RE: Data Response, Set 1B
Ivanpah Solar Electric Generating System (07-AFC-5)

**APPLICATION FOR CERTIFICATION
FOR THE *IVANPAH SOLAR ELECTRIC
GENERATING SYSTEM***

Data Response, Set 1B

FIGURE DR40-1
PROGRADATION OF THE
CLARK MTN BAJADA
 IVANPAH SOLAR ELECTRIC
 GENERATING SYSTEM

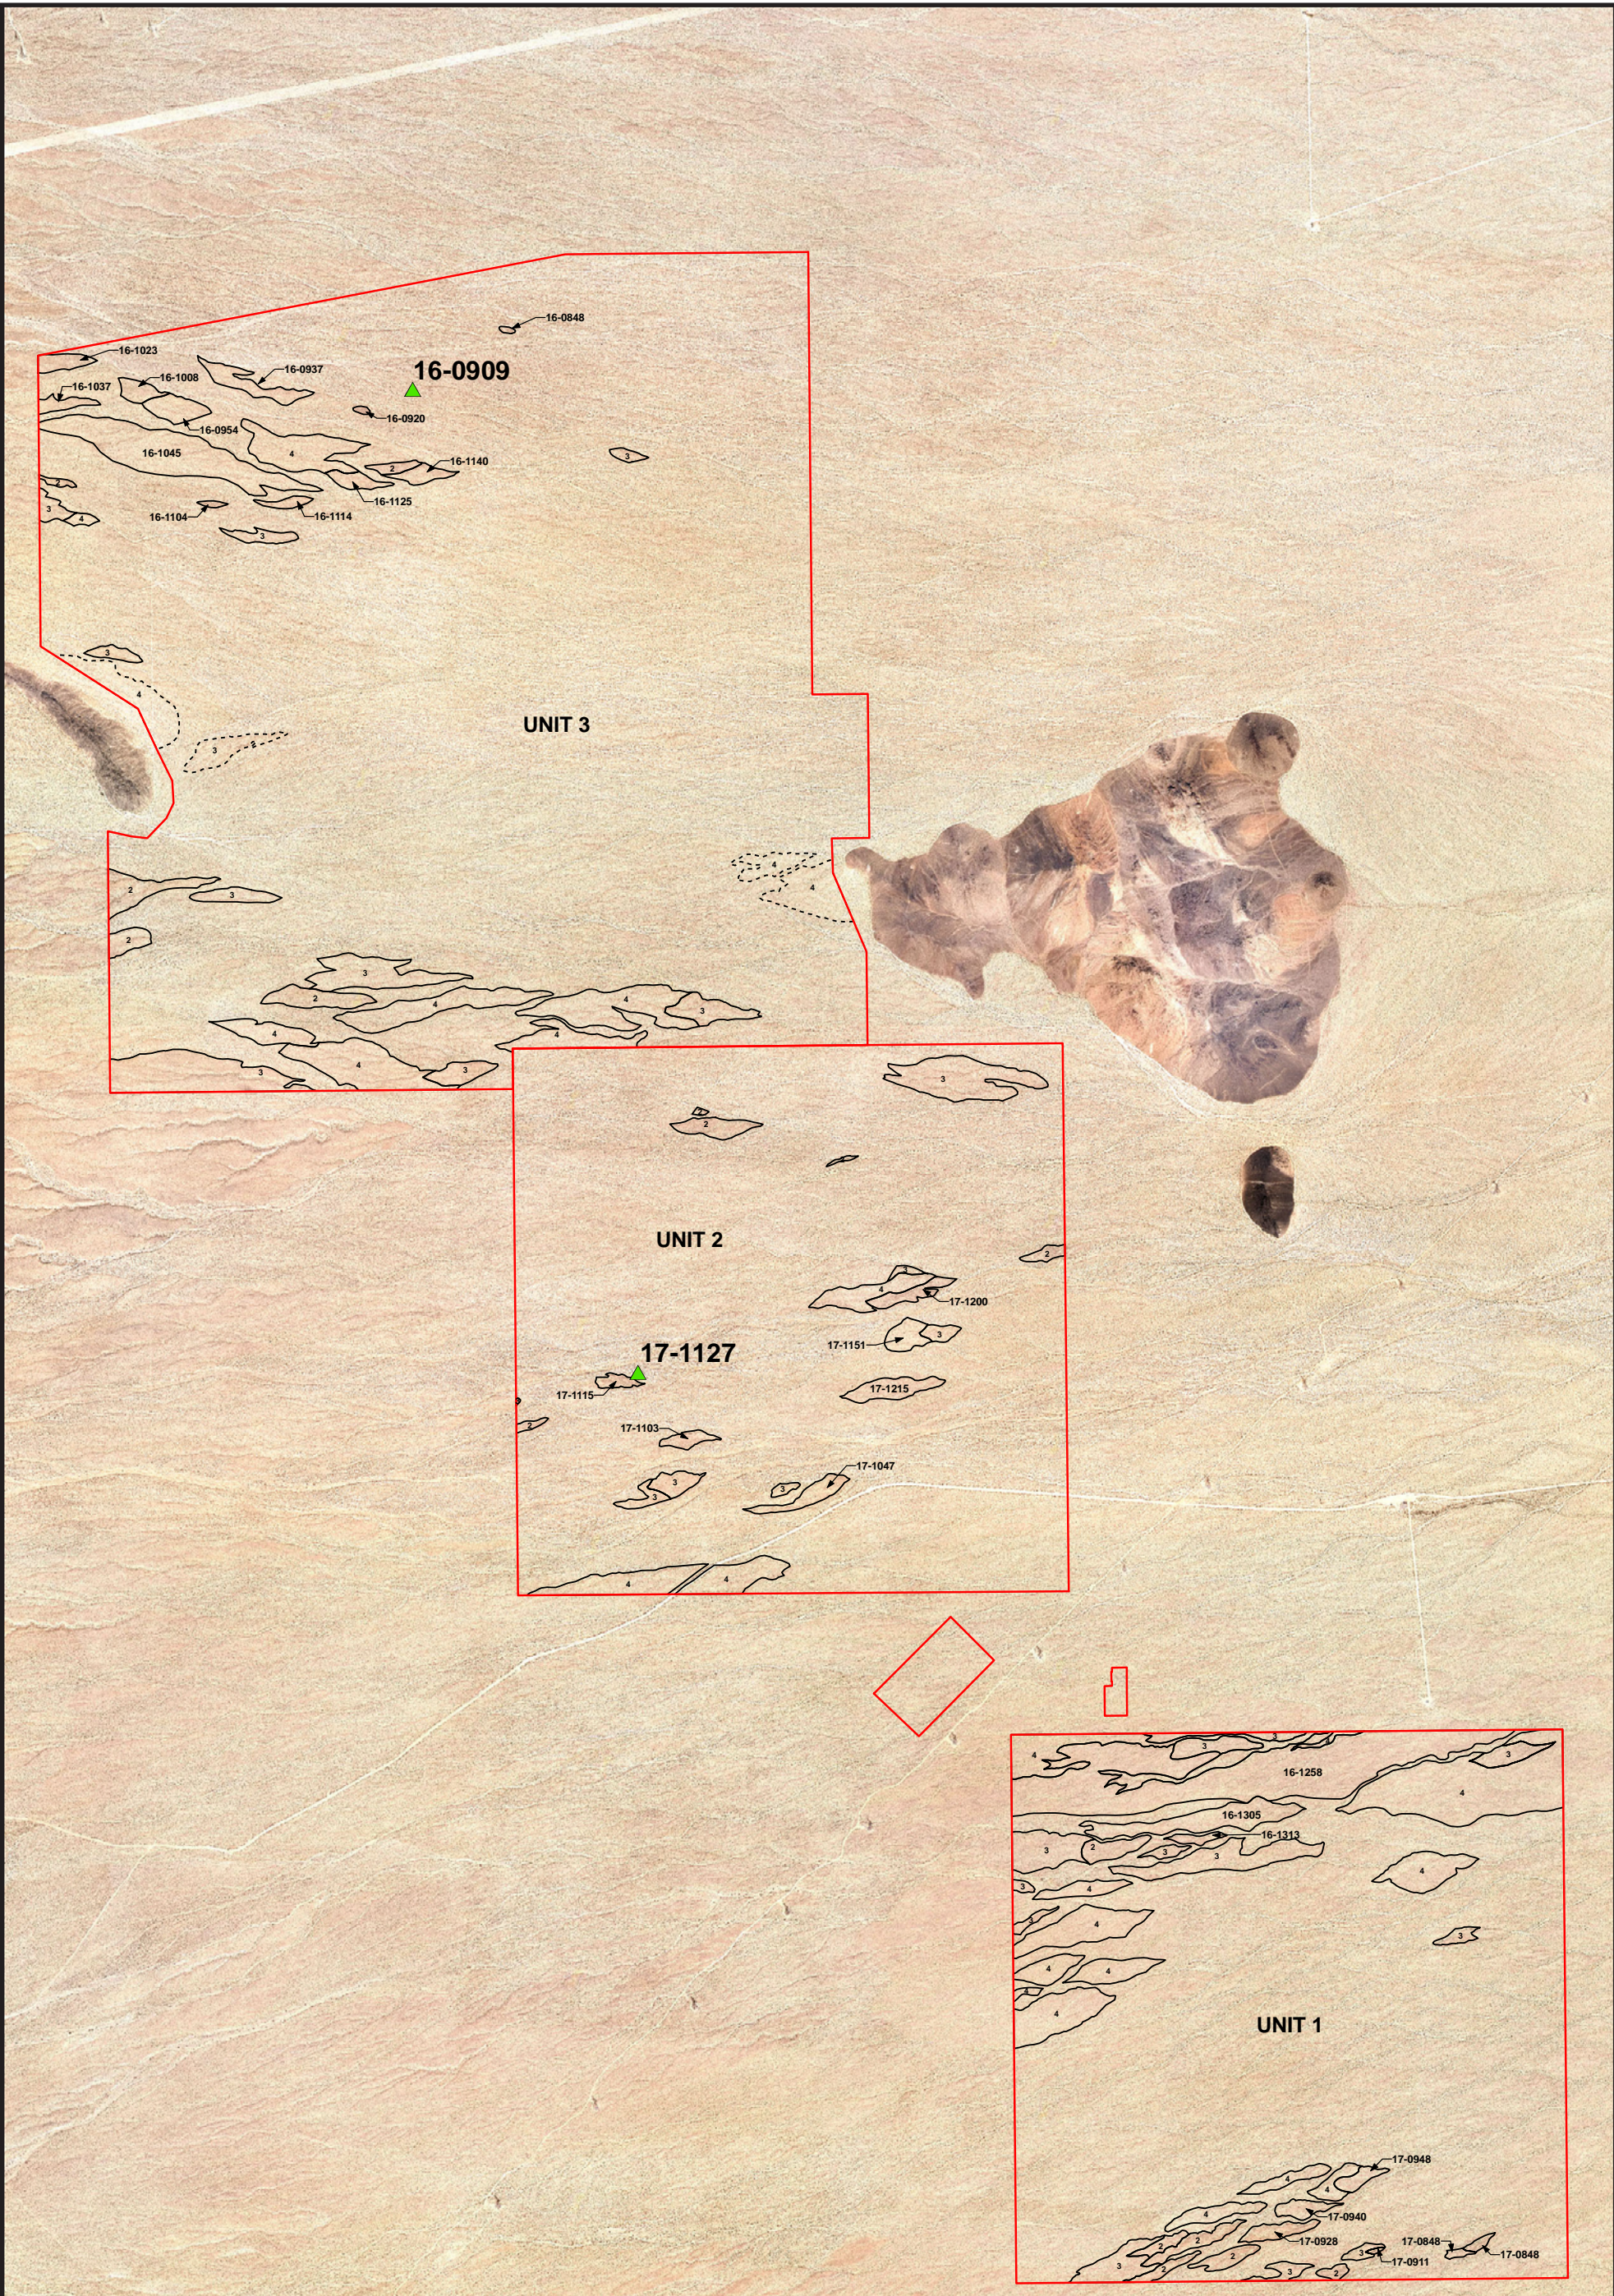
40. Please provide a discussion of the historical geomorphology of the project site to better evidence a consideration of the potential there for buried archaeological deposits. The discussion should describe the development of the bajada on which the project area is proposed with a focus on the character of the bajada's depositional regime since the Late Pleistocene era. The basis for the discussion should be data on the geomorphology, sedimentology, pedology, and stratigraphy of the project area or the near vicinity. The source of these data may be a combination, as necessary, of extant literature or primary field research.

Although the Clark Mountain bajada is composed of fan surfaces that are largely erosional, it appears that there also was a change in morphological style during the middle or late Holocene (the last 8,000 years). Examination of satellite imagery of the bajada toe, and comparison with the adjacent toe of the Stateline Pass alluvial fan (Figure DR40-1), suggests that the bajada was progradational (Table DR40-1) in the geologically recent past. Figure DR40-1 shows the north end of the Ivanpah playa, which was occupied by a perennial lake at least during the early Holocene (ca. 9,600 B.P. [radiocarbon years before present]; Spaulding, 1999). A beach zone is clearly evident at the toe of the Stateline Pass alluvial fan on the north-northwest margin of the playa, and a zone of darker beach material derived from the Clark Mountain bajada extends south along the west shore for another approximately 0.75 mile. However, by the end of this distance, the beach on the west side of the basin is overridden by the toe of the Clark Mountain bajada (Figure DR40-1). For this analysis it is assumed that the beach was formed during the early Holocene high stand of Ivanpah Dry Lake, which is correlated with a widespread and pronounced pluvial episode in this region that ended by about 8,700 B.P. (Wells et al., 2003). The progradation of the Clark Mountain fan toe onto the western edge of the Ivanpah playa apparently occurred afterwards. Progradation was then followed by a switch to the current, erosional style, perhaps during the late Holocene (the last 4,000 years).
